RE: Utah Fuel Company (UFC), Skyline Mine No. 1 - Dike in the 7 Left "B" Longwall Panel

MINOR MODIFICATION TO
MINING PLAN APPROVED BY
BUREAU OF LAND MANAGEMENT

**UTAH FUEL COMPANY
SKYLINE MINE No. 1
UPPER O'CONNOR SEAM
Proposed Plan**

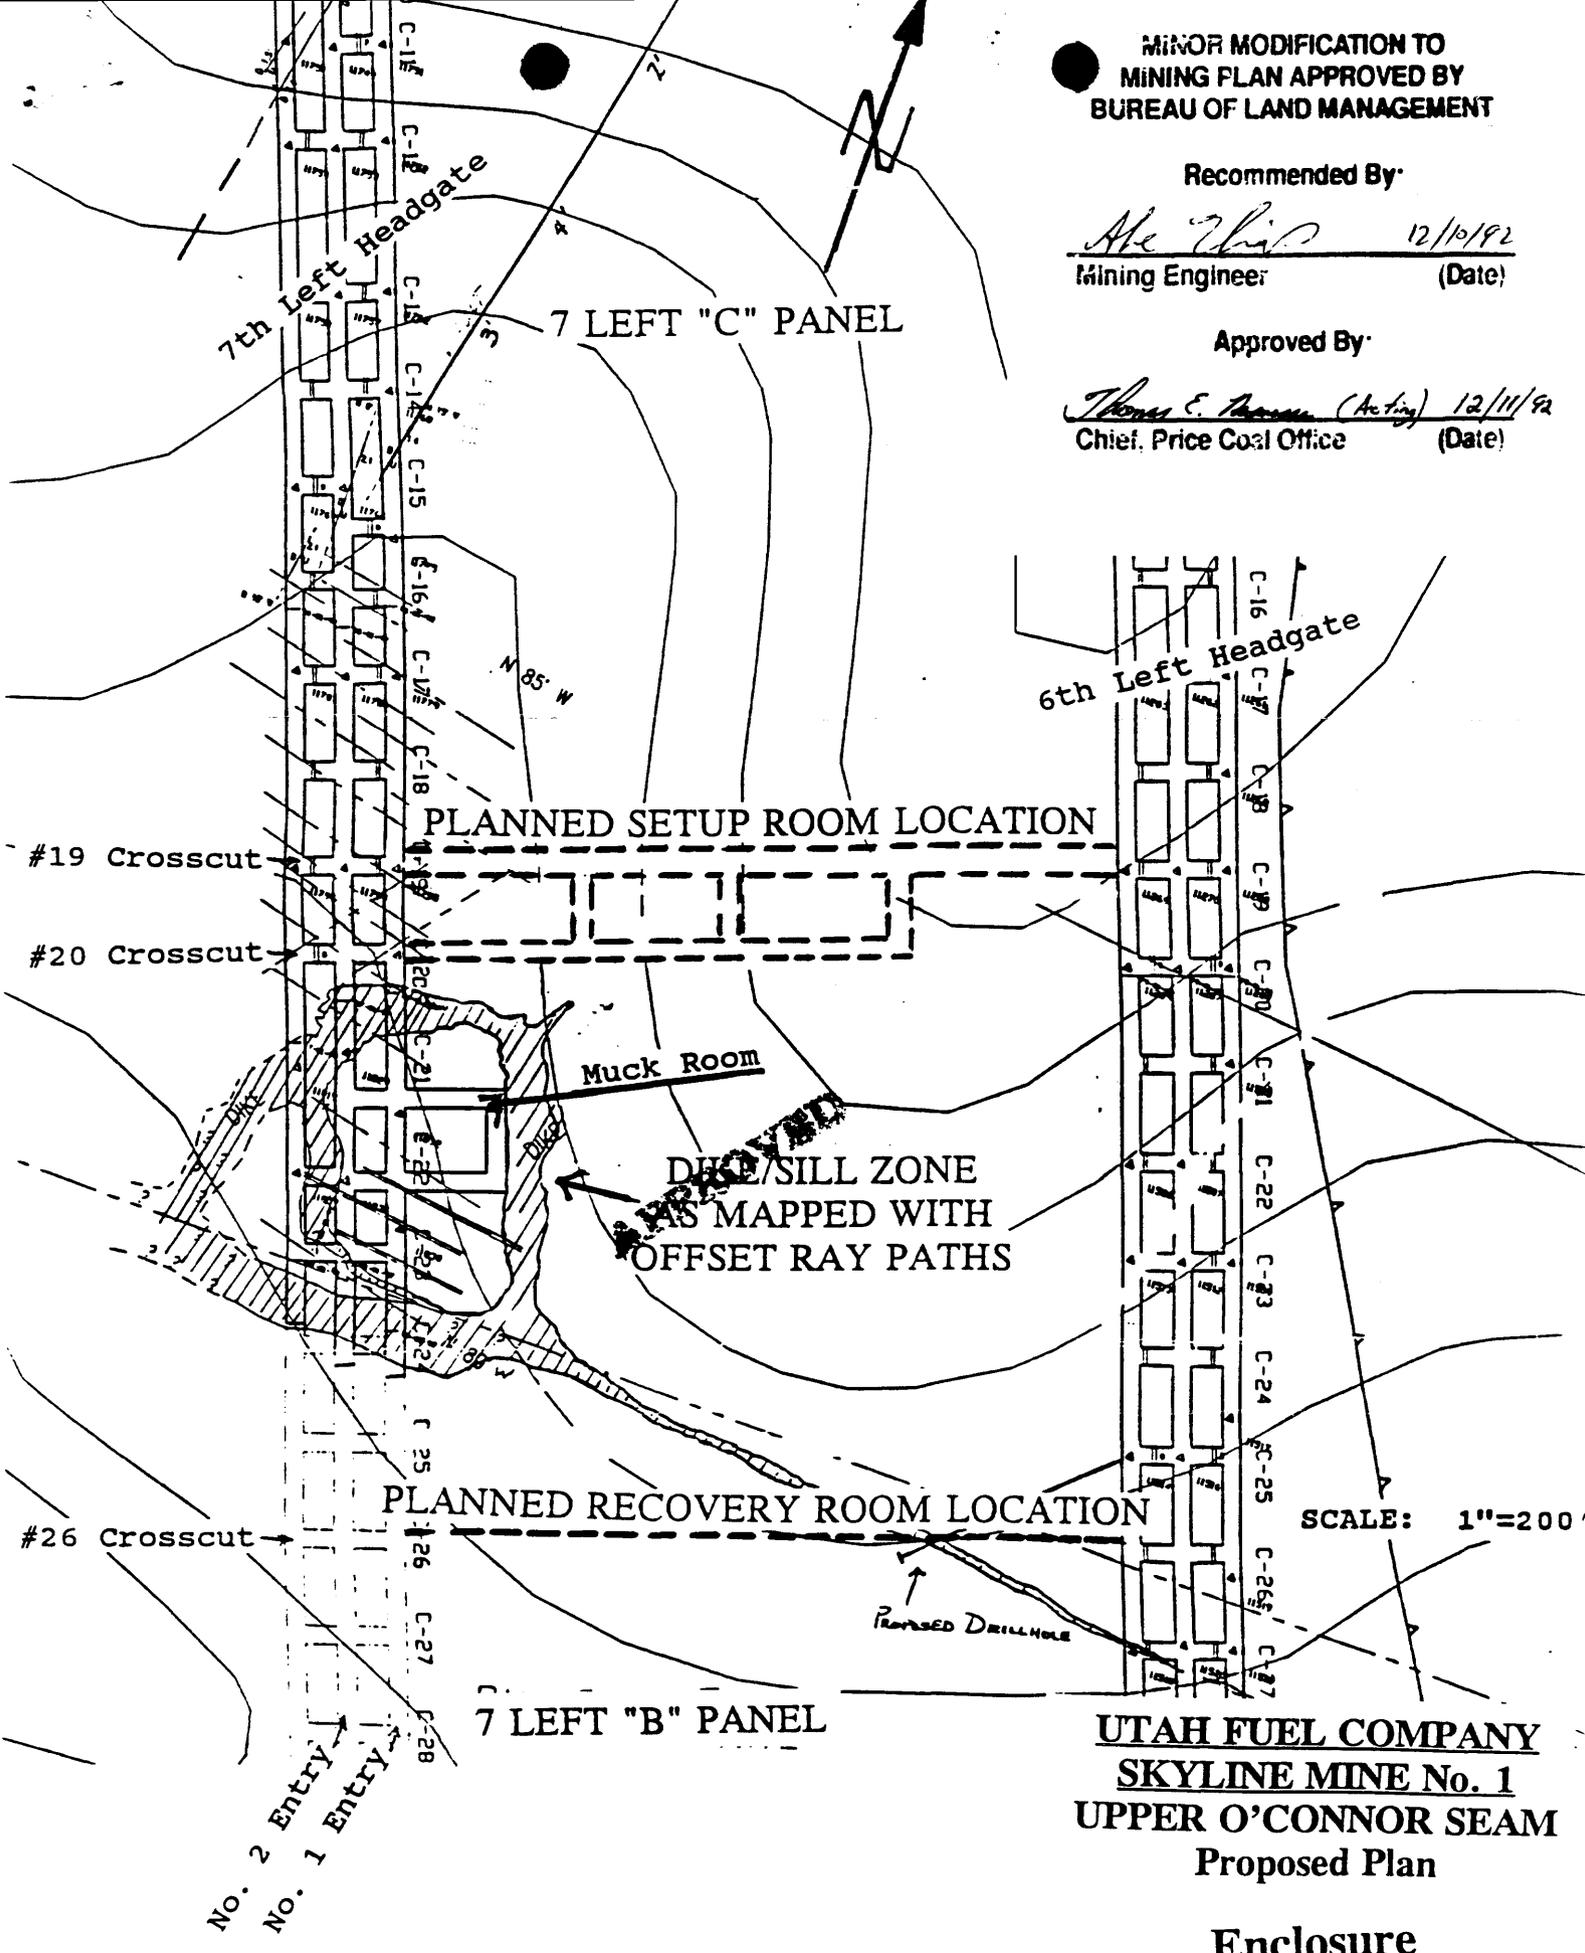
The approved mining plan was to develop the 7th Right headgate entries and setup rooms to begin mining the 7 Left "B" longwall panel at #38 crosscut and conclude mining this panel at #5 crosscut. UFC is now proposing to stop mining the 7 Left "B" longwall panel at #26 crosscut (planned recovery room) and develop new setup rooms at #19 and #20 crosscuts (planned setup room) to mine the new 7 Left "C" longwall panel (see enclosure). UFC also proposes no mining in the block of coal between #20 and #26 crosscuts except for developing approximately 100 feet of muck rooms at #21 and #22 crosscuts.

According to UFC, an unexpected occurrence of an igneous dike zone was encountered between #20 and #25 crosscuts while developing the 7th Left headgate entries. Horizontal drilling and a Radio Imagery Method (RIM) survey conducted by company personnel delineated the dike's configuration (see enclosure). The dike body is composed of a very hard material surrounded by a weak roof and rib section.

An igneous dike trending east-west between #20 and #24 crosscuts of the 7th Left headgate entries was observed during the mine inspection conducted August 5, 1992. A branch of the dike 55 feet wide was measured between #20 and #21 crosscuts. Four small fingers, each ranging from one foot to four feet wide emerged in the coal between #21 and #23 crosscuts. The 7 Left headgate entries were intersected by another branch of the dike between #23 and #24 crosscuts. Drilling and shooting techniques were used in this area because the dike material is very hard and is difficult to mine using continuous miners. Solid steel mats and

a combination of seven and ten foot roof bolts were used to control the fractured roof and the weak rib in this part of the mine. A previous inspection (9/27/91) documented that a dike zone with the same characteristics was encountered while developing the 6th Left headgate entries at #28 crosscut and was measured six inches wide. The horizontal drilling and RIM survey data was analyzed and does confirm the dike's configuration as reported by UFC.

Based on this information, the BLM concludes that it is not feasible for longwall mining equipment to cross the dike and therefore, the coal reserves between #20 and #26 crosscuts are not recoverable utilizing longwall mining equipment. However, there is potential for recovering a portion of the reserves in this block which are unaffected by the igneous dike utilizing a continuous miner.

Therefore, the BLM has authorized UFC to develop the muck rooms at #21 and #22 crosscuts, stop mining the 7 Left "B" longwall panel at #26 crosscut, and develop new setup rooms at #19 and #20 crosscuts to mine the 7 Left "C" longwall panel. This confirms the verbal approval given to UFC on August 5, 1992. We estimate that approximately 25,000 tons of additional coal between #20 and #26 crosscuts could be recovered by first mining methods. Before extraction of the 7 Left "C" longwall panel begins, UFC must submit for BLM approval either mining plans for obtaining additional recovery for the reserves in question or appropriate justification explaining why additional recovery is not possible.
